Re: Fifteenth Avenue Business Hub (SSD 6407) – Heritage - response to Liverpool City Council's submission

Please find here a response to the following heritage issues that have been raised by *Liverpool City Council* (LCC) in relation to the exhibition of SSD 6407 (as dated 11 December 2015) and the Aboriginal and historical archaeological assessment prepared for the FABH project by DSCA in May 2015.

Existing condition of the FABH study area

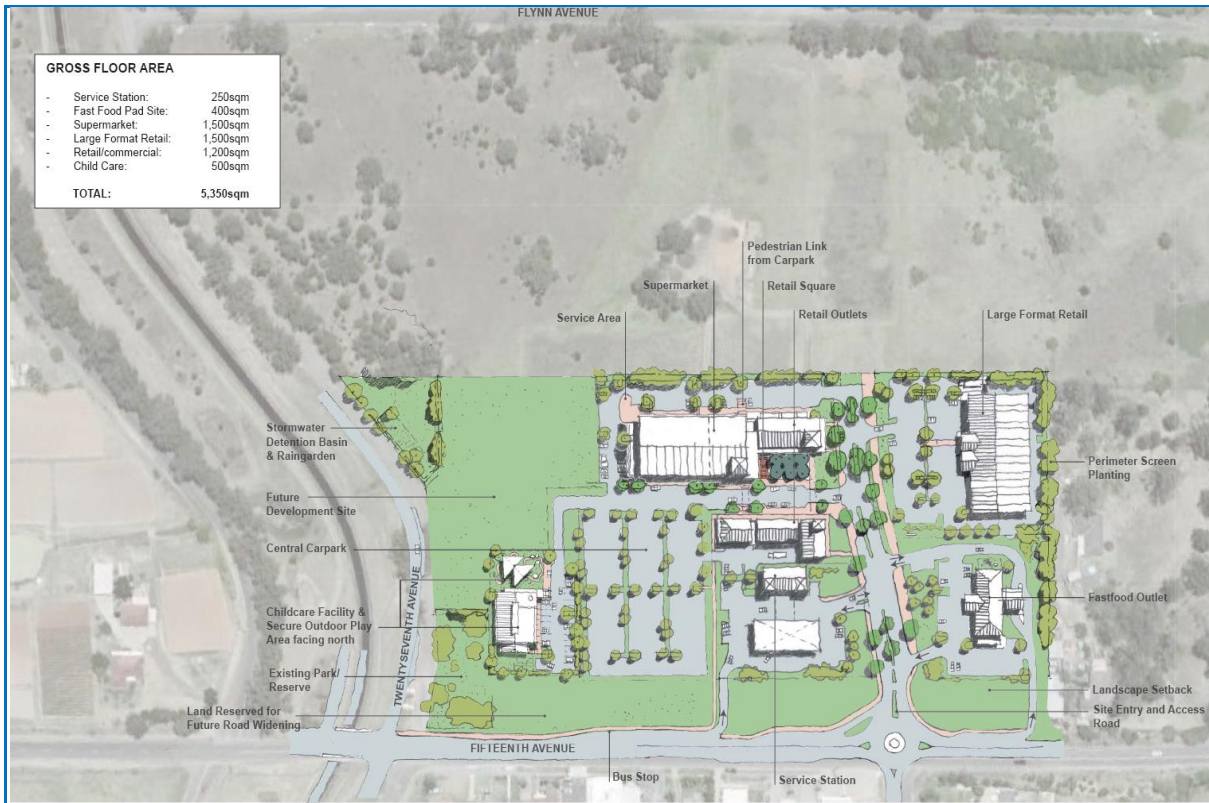
In this respect, LCC identify that no comprehensive assessment of the proposed development in the vicinity of the heritage items has been provided. While it is noted that the proposal will be contained within the boundaries of the subject site and will not encroach into the physical curtilage of either heritage item in the vicinity (thus conserving significant fabric), the settings of both heritage items will be impacted by the proposal. In this regard, LCC further note that:

- a) *The planned widening of Fifteenth Avenue will dramatically reduce the size of the heritage listed park.*
- b) *The location of the proposed child care facility in conjunction with the future road widening will impact on the amenity of the park and the public's ability to appreciate and engage with the war memorial situated in the park.*

LCC recommend in order to manage the cumulative impacts of both the subject proposal and the road widening that the proposed child care facility be relocated to the north and should extend no further south than the northern boundary of the Kirkpatrick-Boyland Park and a vegetated buffer incorporated along the eastern boundary of the park. LCC recommend the car park could be extended towards the Kirkpatrick-Boyland Park boundary without impacting significance. LCC also recommend that the following conditions are applied to any consent issued for the works on the site:

The images above of Boyland-Kirkpatrick Park above in particular illustrate that the aesthetics and amenity of the place and its setting can be improved. The road edges particularly at the twenty Seventh Avenue access to the memorial park are in poor condition and would be improved by future road upgrades in the locality. The current entry to the park, with its small allocation of car parking bays and ad-hoc 'turning circle' on Twenty Seventh Avenue is comparatively unsafe and also visually uninviting. The definition of the boundaries of the park are also insubstantial and unattractive (barbed wire fences) and could be given greater mass and softened by planting along the 'edges' it shares with the FABH site. The features and facilities in park (shade trees, seating etc) excluding the memorial stones themselves are basic and unobtrusive in nature and scale. This is to the extent that without local knowledge people passing by are unlikely to be aware that this place is a WW1 place of commemoration. The locality presently has a distinctly 'temporary' or 'forgotten' feel about it. Disruption to the views to and from the park as a result of the proposed redevelopment, which are neither significant in a broad heritage context nor long-established, will affect 'sightlines' that are present diminished by the unsympathetic nature of the local streetscape setting at the junction of Fifteenth and Twenty Seventh Avenues.

LCC's recommendations to manage the cumulative impacts of the FABH proposal and road widening will help mitigate visual and amenity impacts to the setting of the park by relocating the proposed child care facility further to the north (only as far south as the northern boundary of the park) with a new vegetated buffer incorporated along the park's eastern boundary. LCC's recommendation that the car park be extended towards the Kirkpatrick-Boyland Park boundary would also be acceptable on archaeological grounds. There are no expectations the areas concerned (which are heavily disturbed) will contain or retain any archaeological features or deposits of significance.
